23RD MAY 1884, No. 1297 W., PUBLIC WORKS.

Christ Church, Cuddapah

Stating that it is not possible to make any grant of funds for the erection of a belfry for —, and that the question as to departure from the original design for the church will be remitted to Mr. Chisholm on his return from leave.

END ELEVATION.

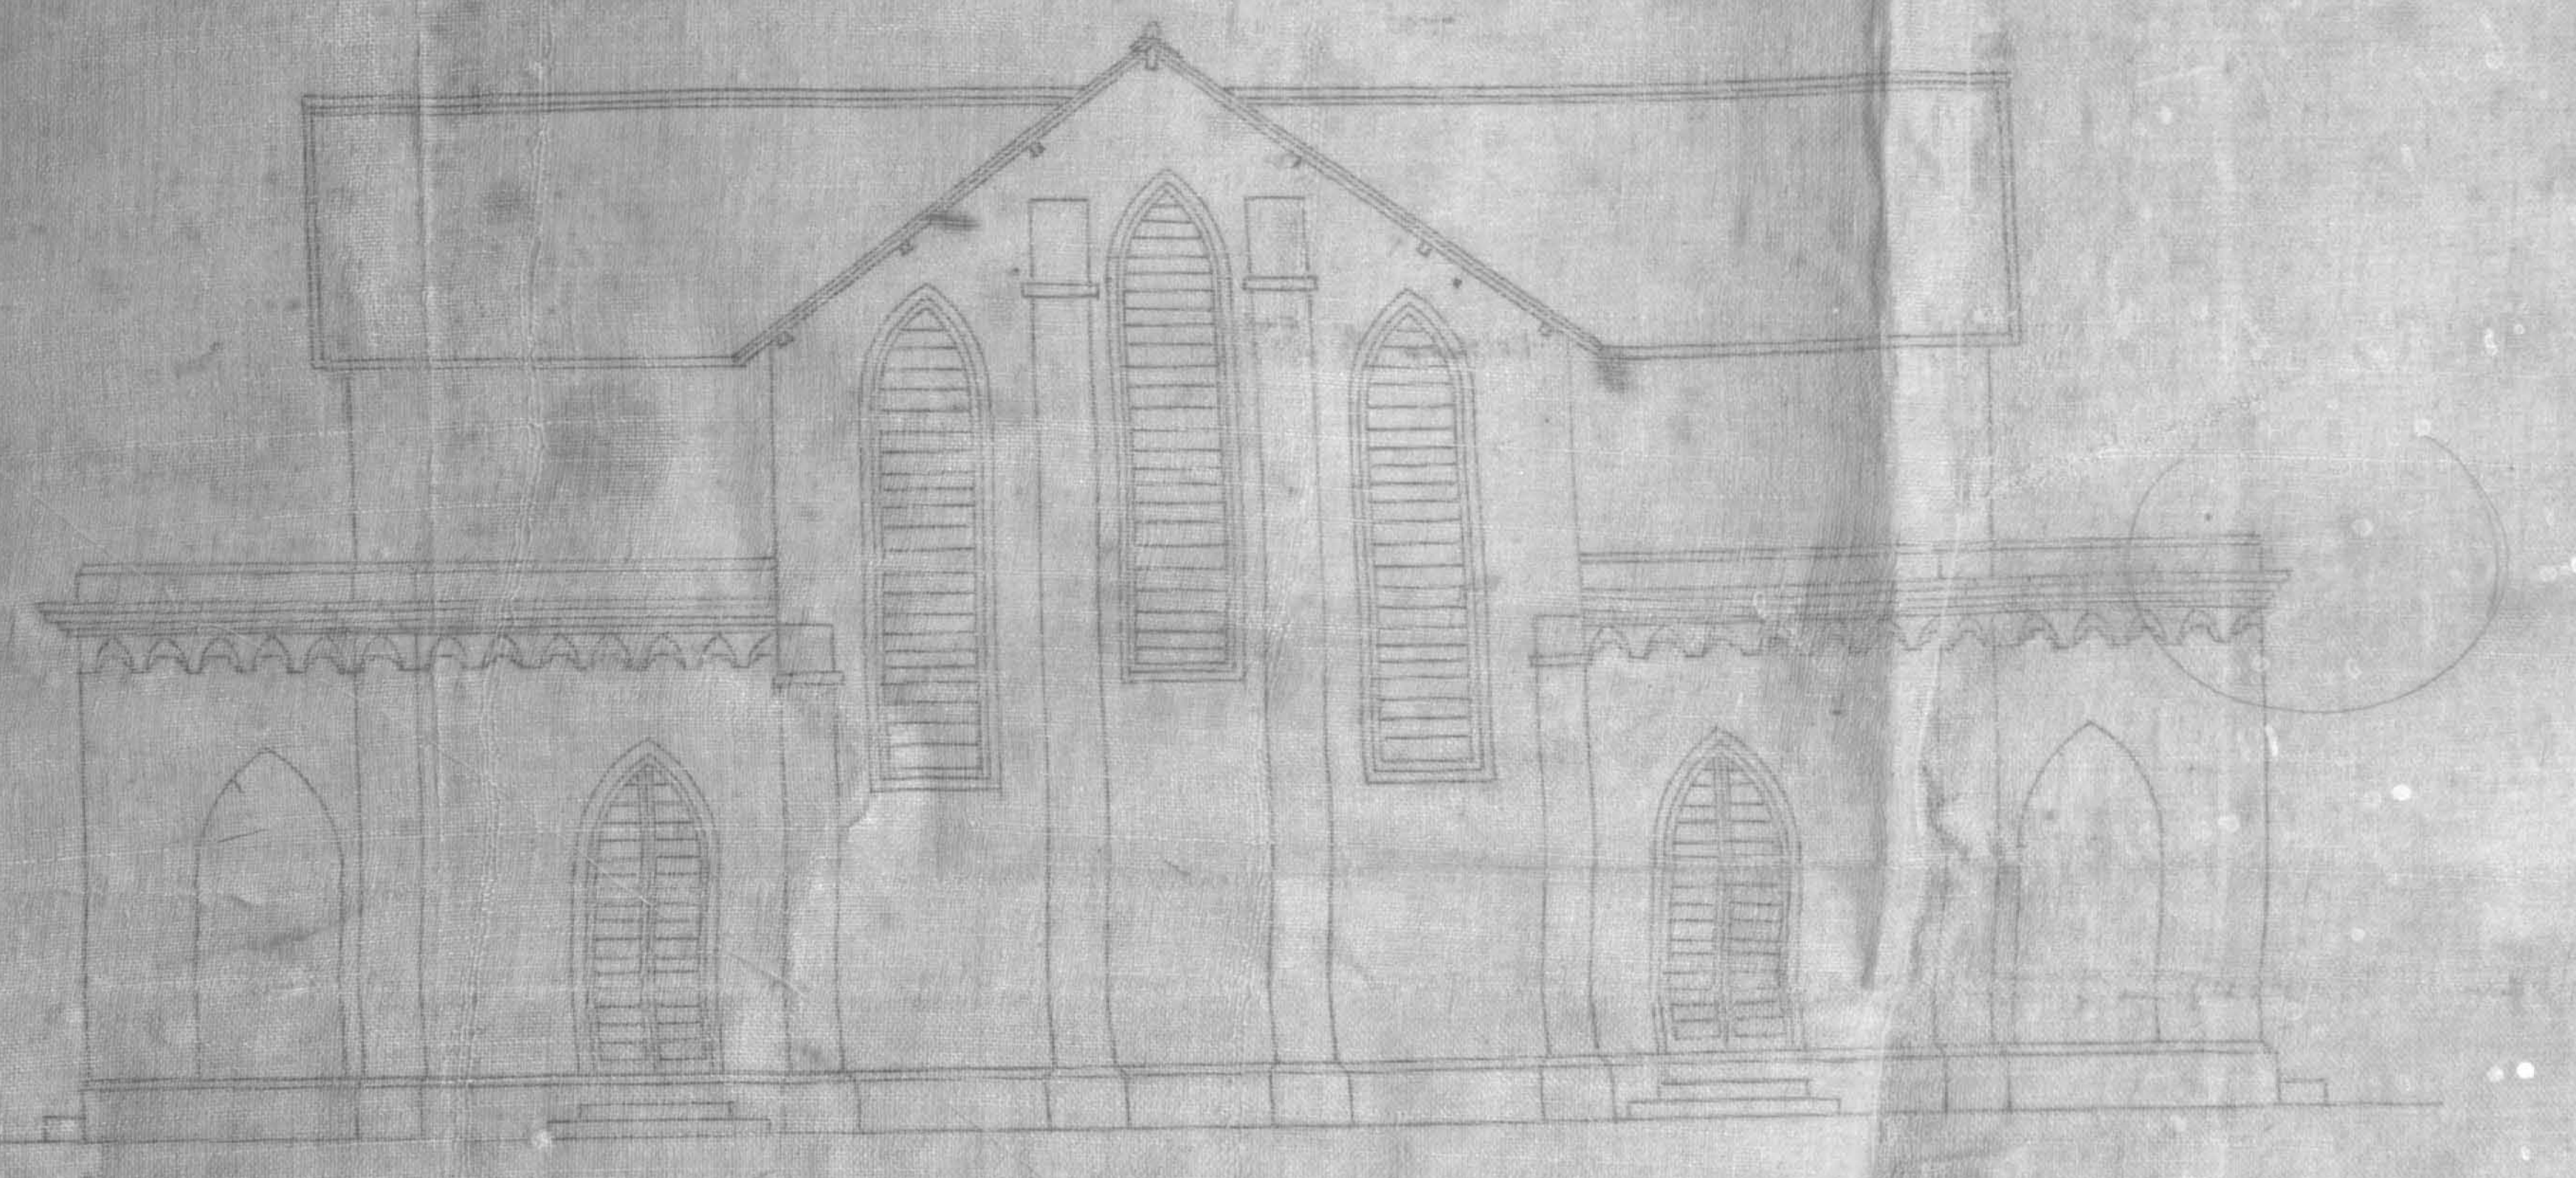
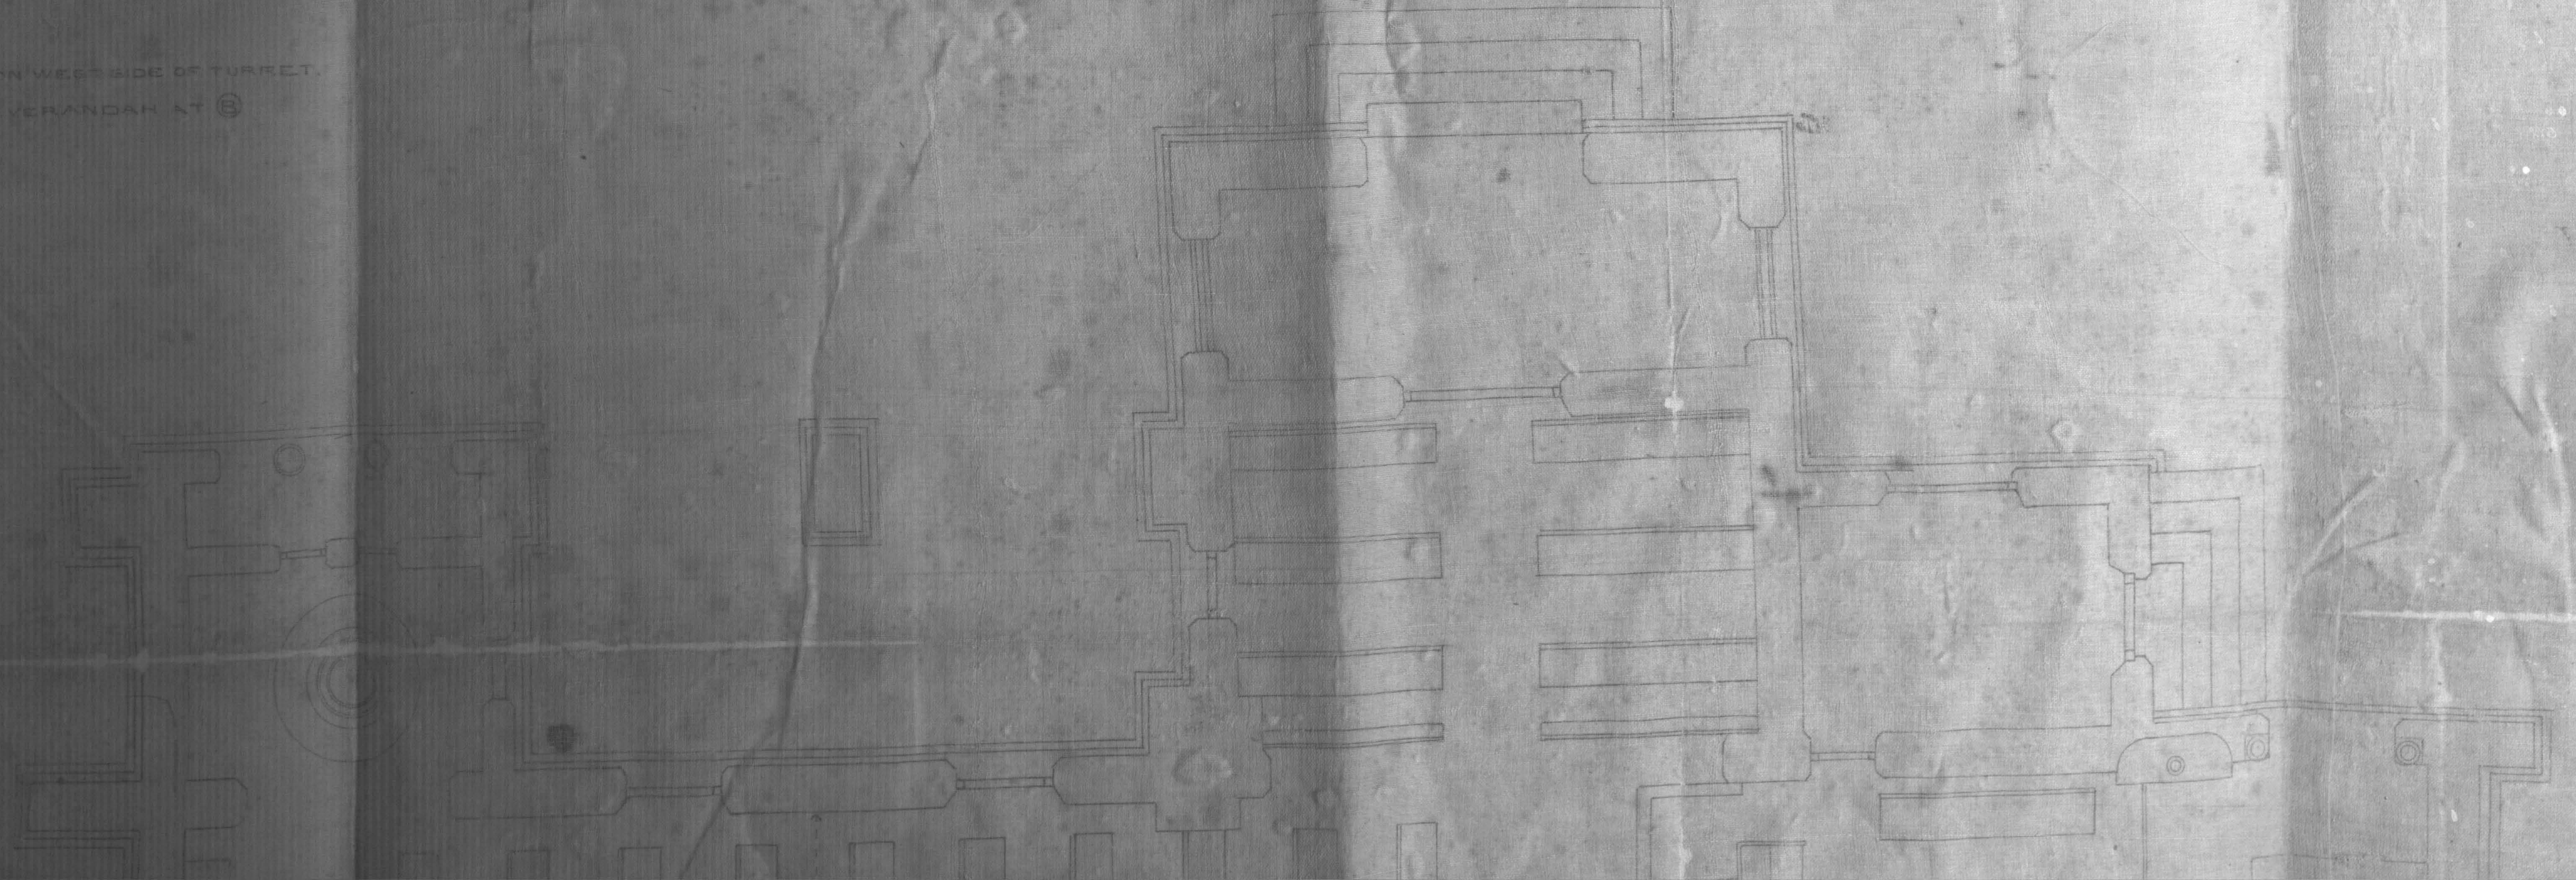
The belfry will occupy a space in the Corner of the South verandah. It may be built quite free of the building in that corner if thought desirable and not as shewn in the plan. The turret will at bottom be 7 feet square outside and 5 feet diameter inside, Containing a circular spiral Stairs formed of Stone slabs about 8" thick. 28 feet over basement level the inside of the turret will become 5 feet square and then the first stone roof will taper upwards and thus become about 4 feet square over which the wooden top, to be supplied from Madras, will be firmly secured in any manner the Executive Engineer may determine. where the main roof joins the turret Lead flashing should be used. The materials are left to the Executive Engineer. Cuddapah. to decide upon as well as quality of work &c.

In compliance with Public Works G. O. No. 1921 W dated 9th July 1883, I have the honor to enclose a plan and Estimate, the latter amounting to Rs 718, for erecting a Belfry to the Cuddapah Church. The Elevations sent by the Executive Engr. Cuddapah Division shew that the Church has not been erected in accordance with the design originally supplied by Mr Chisholm. I enclose one plan of Mr Chisholm's design for comparison, and shall be obliged by its being returned when done with. Apparently from the elevations supplied the structure now presents a rather incongruous appearance. I have found it difficult to design a suitable belfry to accord in any way with the structure as erected. I see no objection to the belfry (which will be very light) being erected in the corner of the south Verandah as shewn on the plan. The work there is very massive and will, no doubt easily bear the comparatively small weight of the turret. I propose utilizing a top now lying at the School of Arts which was intended for a Clock Turret in Madras now abandoned. I have written no detailed specification as this can best be done by the Executive Engineer Cuddapah Division. But the specification describes in a suggestive way what the design intends to accomplish.

A DOOR SIMILAR TO Ⓐ ON WEST SIDE OF TURRET.
LEADING TO TOP OF VERANDAH AT Ⓑ
